# NURSING HOME

LOTS 177-179 DUNCAN STREET, **VICTORIA PARK**

# DESIGN REPORT FOR WAPC

Prepared by 28/08/2020 Issue Date

### PROPOSED DINING ROOMS FACING WESTERN SUN

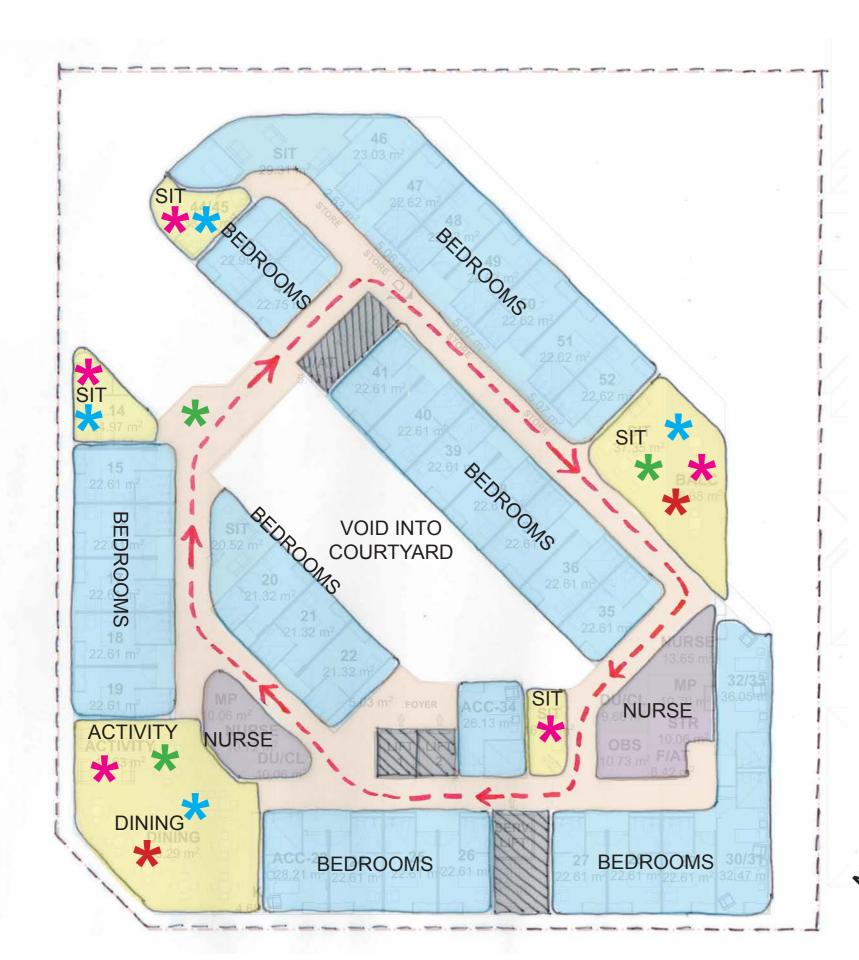
- Orientation of the building will result in heat loading in the corner of the building (Shepperton Road and Duncan Street). Proposed metal screens will offer little protection.

- There is still concern regarding the solar penetration and heat loads to the Duncan Street elevation. It is expected that the metal grid/artwork is unlikely to do anything. There is a large concern about the use of the north eastern areas on a summer afternoon. The heat will likely become unbearable.

Limited exposed glazing due to planters, screens, double glazed units and internal window treatments.

### **SCREENING FOR WINDOWS OVERLOOKING NORTH-EAST CORNER**

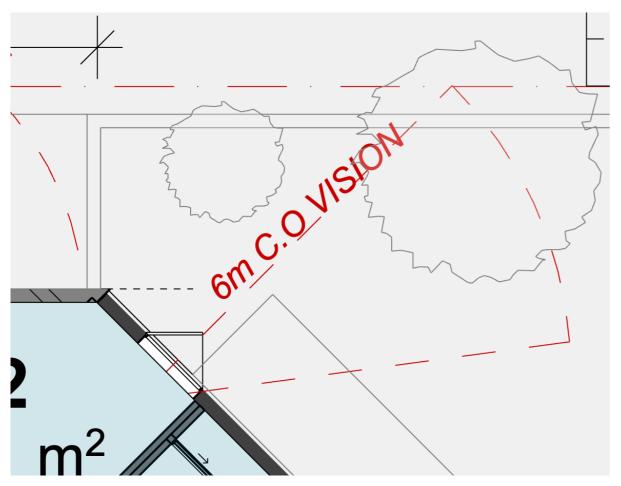
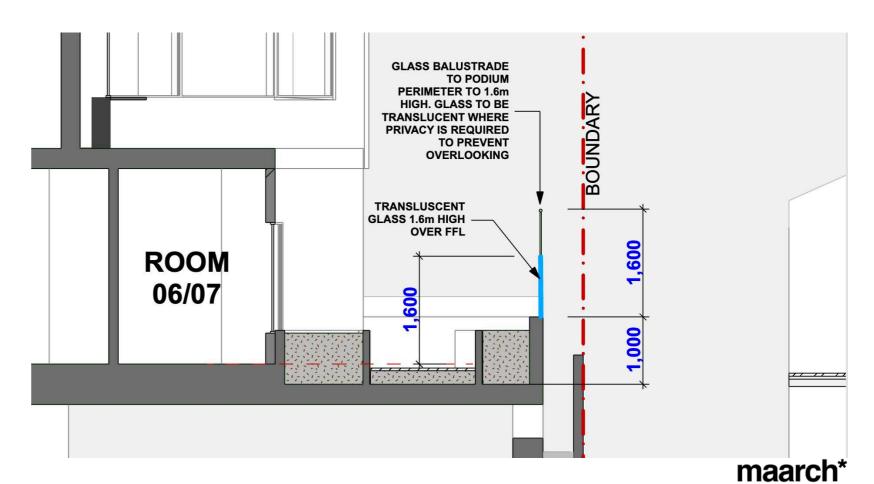
- The removal of the ACC units would also allow additional light to enter the southern end of the corridor.
- Diagonal slash on the horizontal screens, grain is too large in the corner. The grain of the major screen elements is a bit too large and could be finer to help reduce to a more residential scale.
- The canopy at the first floor level projects over the landscaping area and stops rain getting to the planting the depth of the canopy is superfluous and compromises the landscape in the setback a nice delineator but projects too far.
- The treatment of the proposed air grille/screens to Shepperton Road are of some concern from a visual perspective applicant should further explore a suitable screening strategy

Cone of vision diagram for rooms 47, 82 and 116. \*Refer to Architectural Plans
